# HISTORIC AND DESIGN REVIEW COMMISSION

**HDRC CASE NO:** 2022-345  
**ADDRESS:** 305 LAVACA ST  
**LEGAL DESCRIPTION:** NCB 708 BLK 8 LOT 2  
**ZONING:** RM-4, H  
**CITY COUNCIL DIST.:** 1  
**DISTRICT:** Lavaca Historic District  
**APPLICANT:** Caroline Gado  
**OWNER:** Leslie Jones/1918 MLK DEVELOPMENT GROUP LLC  
**TYPE OF WORK:** New construction of two, 2-story duplex structures  
**APPLICATION RECEIVED:** September 28, 2022  
**60-DAY REVIEW:** Not applicable due to City Council Emergency Orders  
**CASE MANAGER:** Rachel Rettaliata

The applicant is requesting conceptual approval to construct two, 2-story duplex structures at 305 Lavaca.

① FRONT ELEVATION- SOUTH  
SCALE: 1/4" = 1'-0"

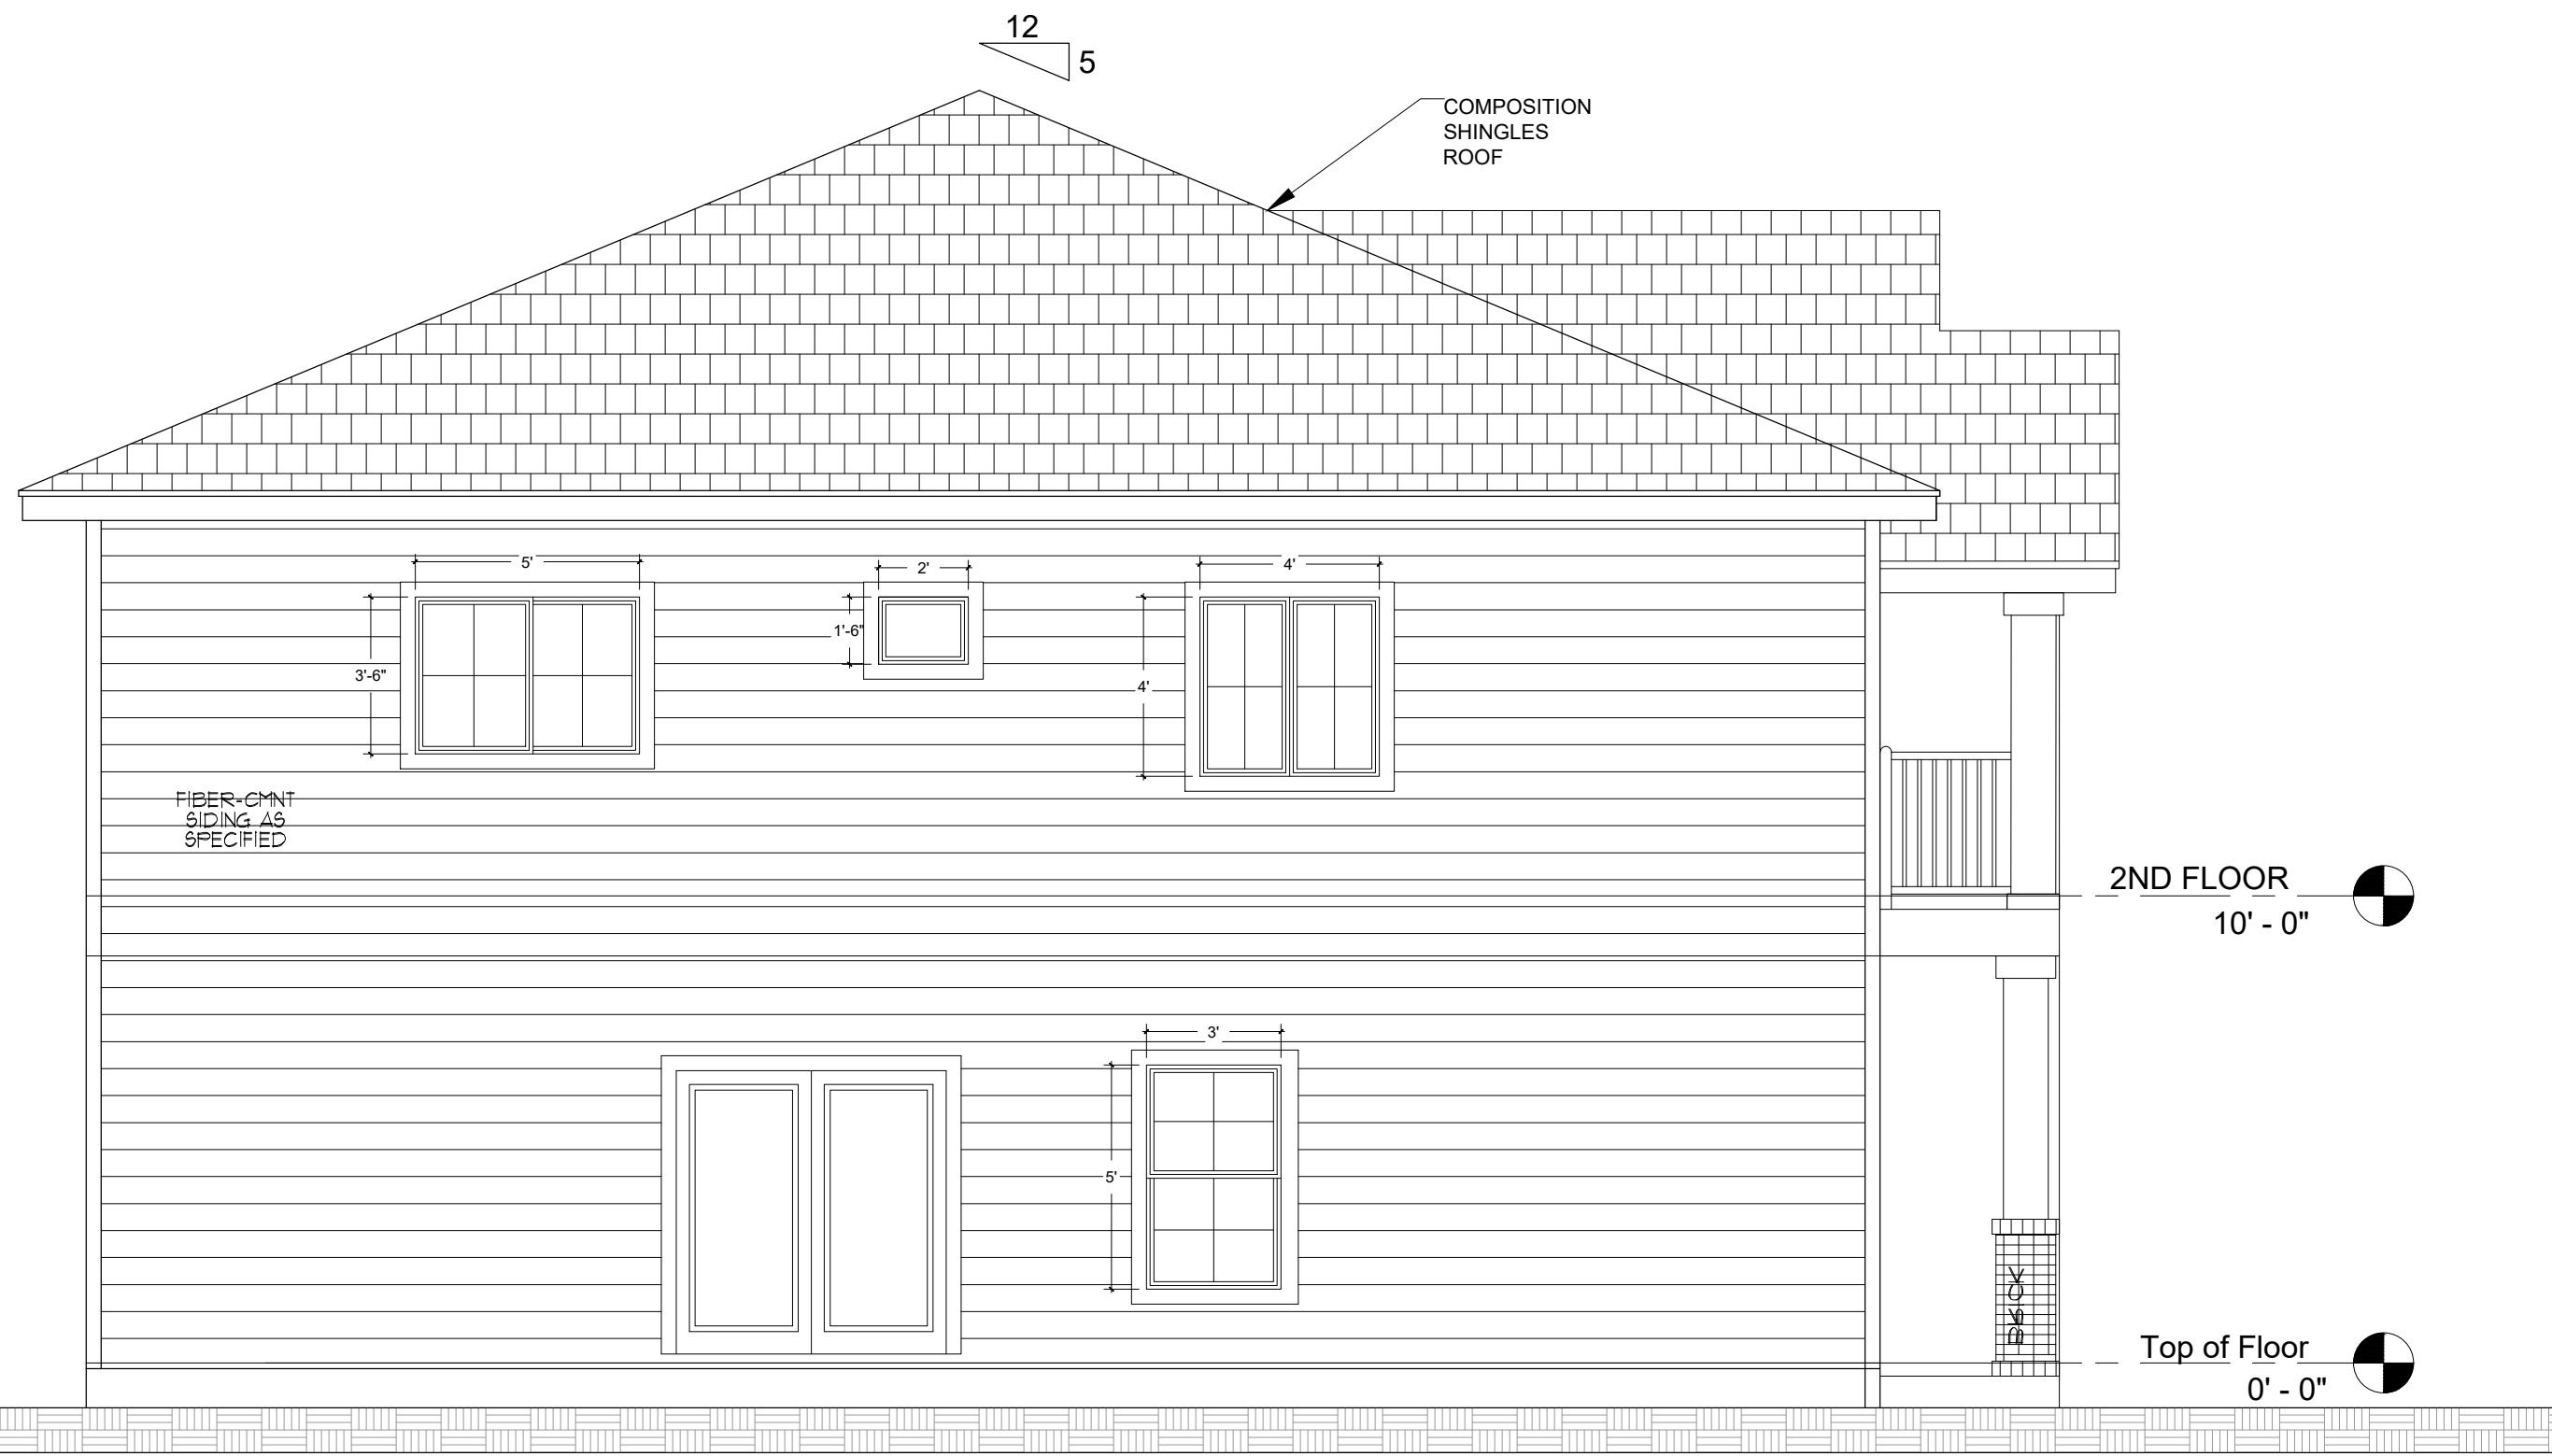
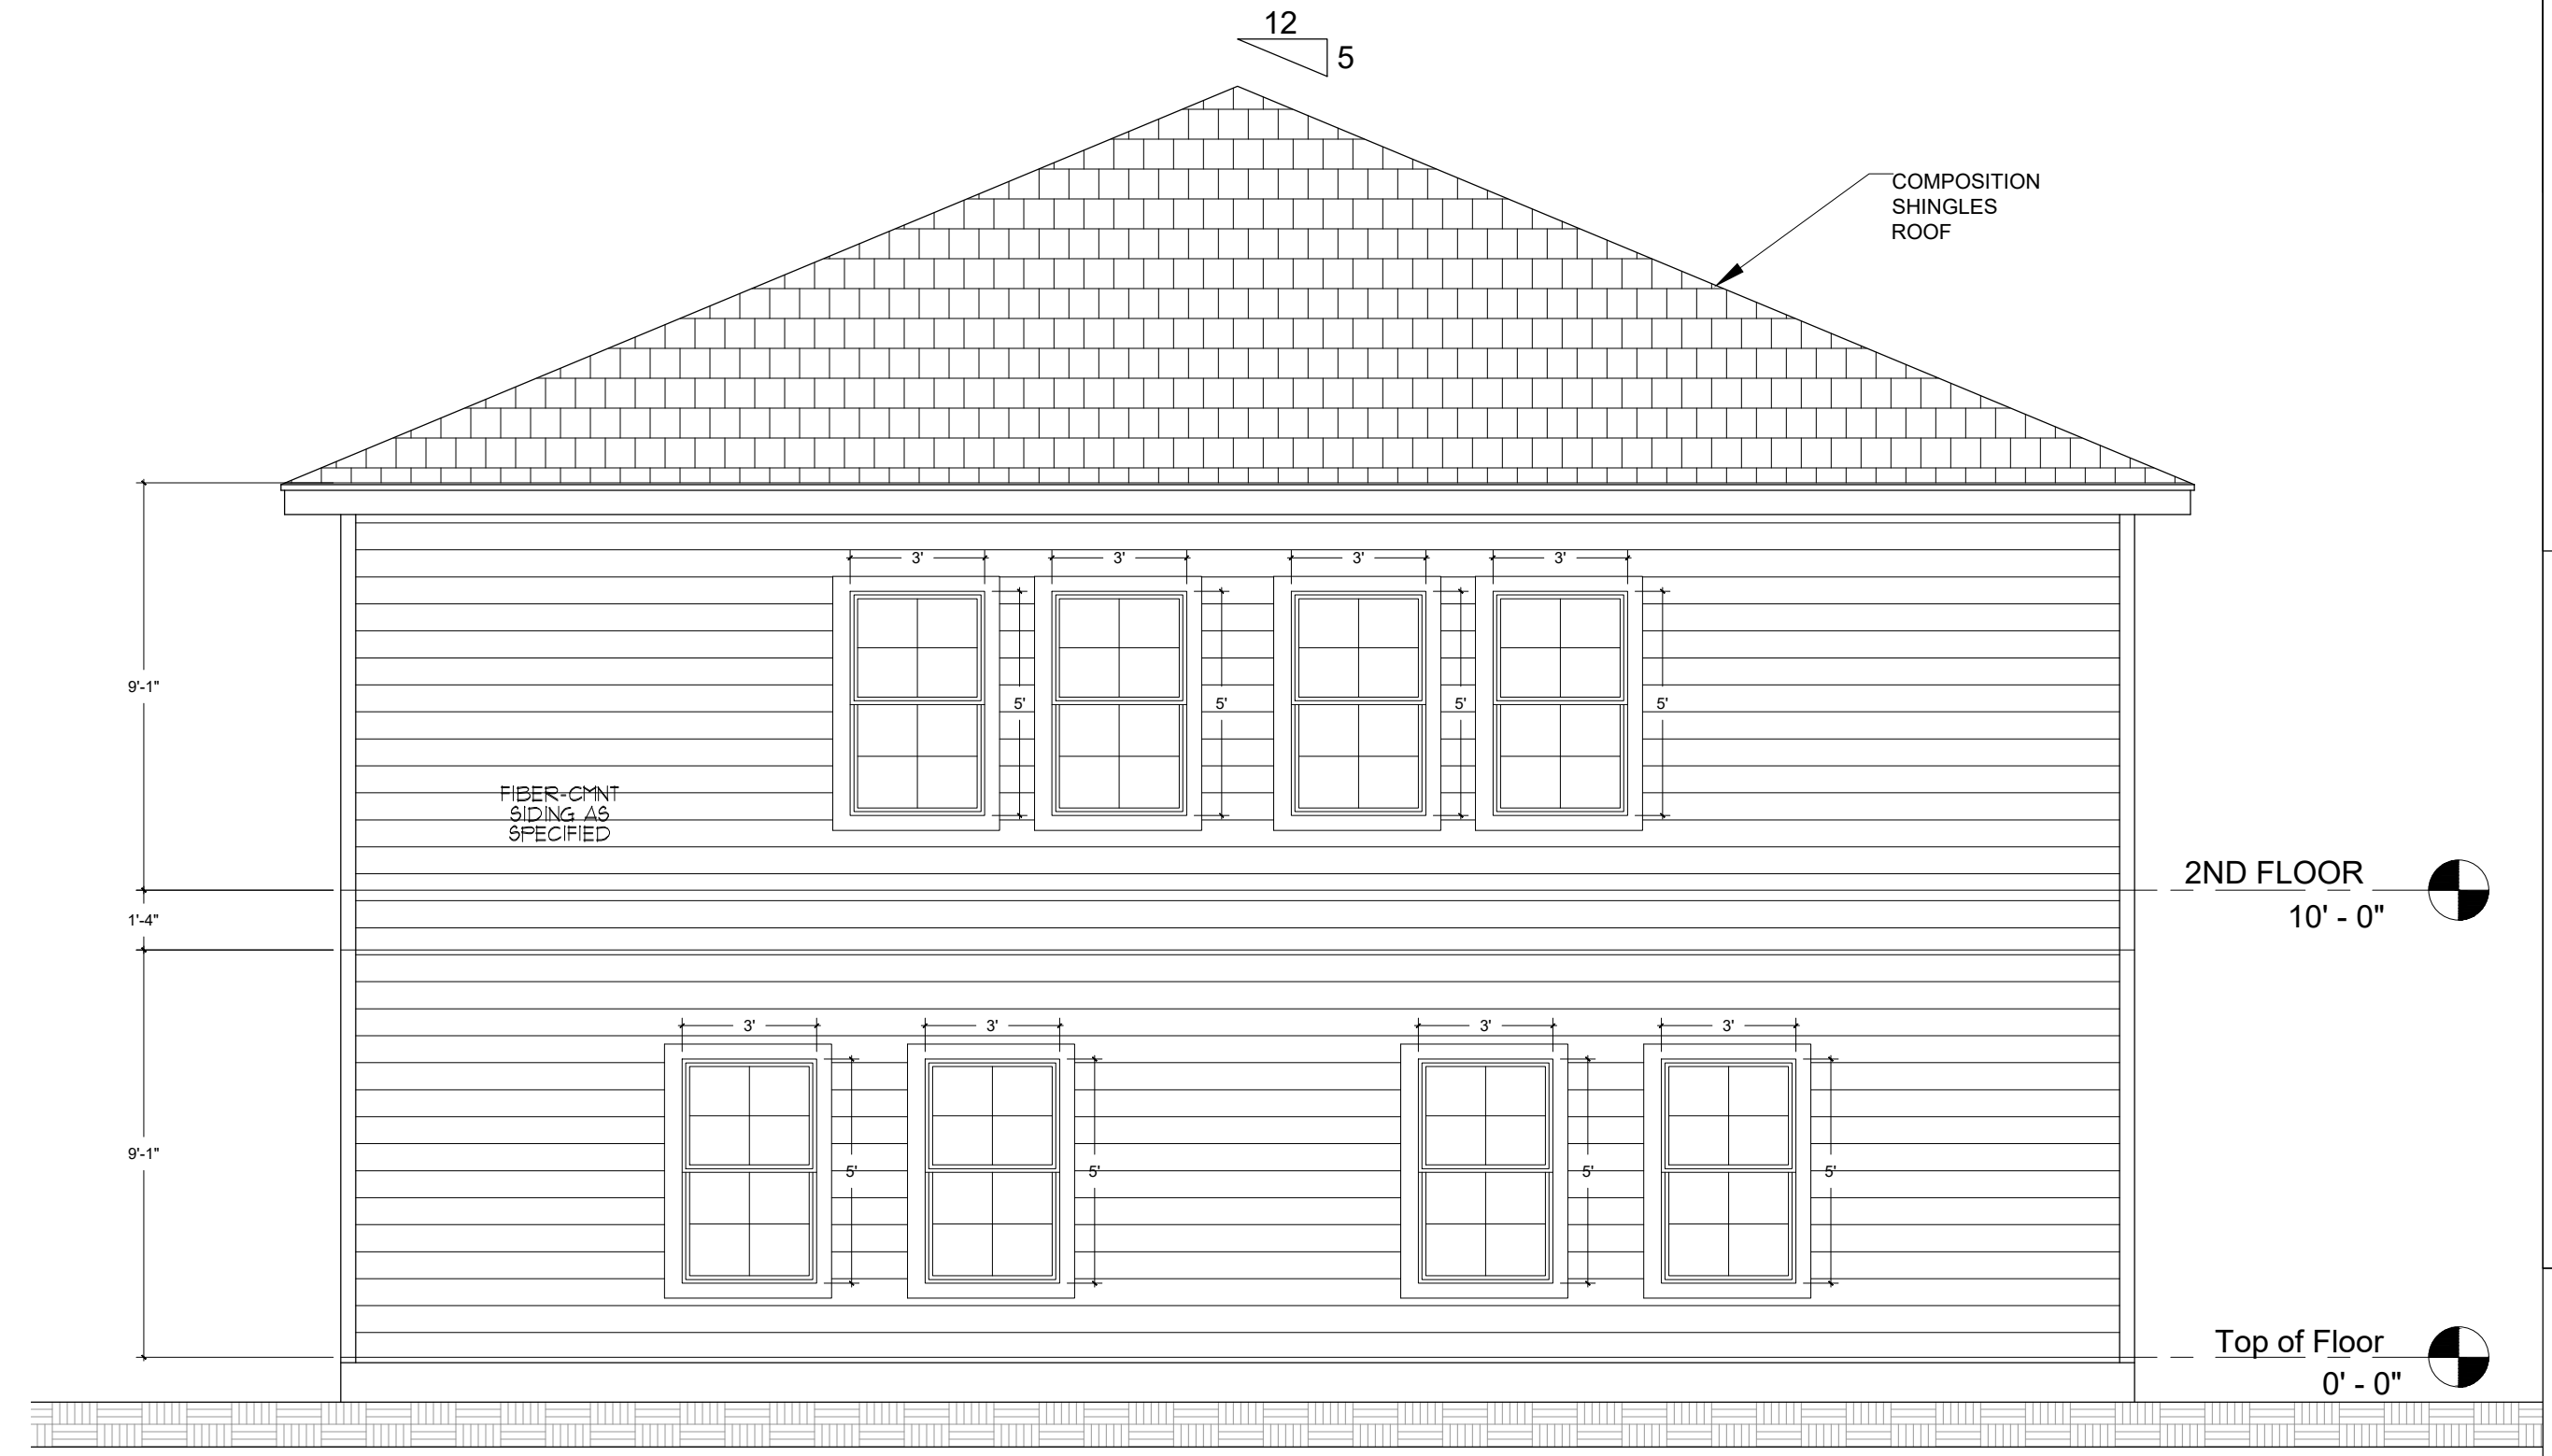
- g. **SCALE & MASSING** – According to Guideline 2.A.i for New Construction, new structures should feature a height and massing that is similar to historic structures in the vicinity. In residential districts, the height and scale of new construction should not exceed that of the majority of historic buildings by more than one story. The blocks of Lavaca and Garfield Alley feature one-story and two-story historic structures. Guideline 2.A.ii for New Construction states that applicants should utilize step-downs in building height, wall-plane offsets, and other variations in building massing to provide a visual transition when the height of new construction exceeds that of adjacent historic buildings by more than one-half story. Staff finds that the applicant should reduce the overall massing.

- i. **ROOF FORM** – The applicant has proposed a pyramidal roof form with double front gables on each of the duplexes. According to Guideline 2.B.i for New Construction, new construction should feature roof forms that are consistent with those predominantly found on the block. The blocks of Lavaca and Garfield Alley feature structures with front gable roofs, cross gable roofs, side gable roofs, hip roofs, and shed roofs. Staff finds the proposal consistent with the Guidelines.

- m. **RELATIONSHIP OF SOLIDS TO VOIDS** – The applicant has proposed to install divided lite one-over-one windows on the duplex structures. The proposed fenestration pattern consists of sets of 2 ganged windows on the front facades, single, ganged, and small fixed windows on the side elevations, and single windows on the rear elevation. The proposed window proportions vary in size and all of the proposed windows do not appear to be in keeping with those historically found in the district. Guideline 2.C.i for New Construction states that window and door openings should be incorporated into new construction with a similar proportion of wall to window space as typical with nearby historic facades. Windows, doors, porches, entryways, dormers, bays, and pediments shall be considered similar if they are no larger than 25% in size and vary no more than 10% in height-to-width ratio from adjacent historic facades. Staff finds that the proposed fenestration should be updated to be more in keeping with the Guidelines.

- o. FRONT PORCH – The applicant has proposed to construct a double-height front porch on each of the duplex structures. The proposed front porches feature square columns, a second-floor porch handrailing, and decorative gable detailing. Staff finds that the proposed columns should be a maximum of 6”x6” in width and feature a traditional cap and base and chamfered corners and that the applicant submits details for the proposed columns and railing.

LG: As far as massing and window and roof shape, this seems to comply looking at the elevations. There is an unusual window orientation, looking at the rear elevation.

LG: I have a design question related to the front elevation and the brick base on the columns. The brick base is something that you may see on a Craftsman home and the columns are more Neo-Classical in style.

RM: The central wall has a strange appearance.

LG: Having two columns in place of the divider wall may be more in keeping with the predominant style of the neighborhood.

RM: I think the brick would work best as a free-standing column as opposed to a column on a brick base.

- ii. That the applicant reduces the massing and provides a diagram showing the height of the proposed structures in relation to neighboring structures, including proposed foundation and floor heights based on finding g and h.

- iv. That the applicant proposes window sizes, patterns, proportions, and trim and sill detailing that are consistent with the Guidelines and historic precedents in the district as noted in finding m.

- v. That the applicant submits details for the proposed porch columns and railing based on finding o. The proposed columns should be a maximum of 6”x6” in width and feature a traditional cap and base and chamfered corners.
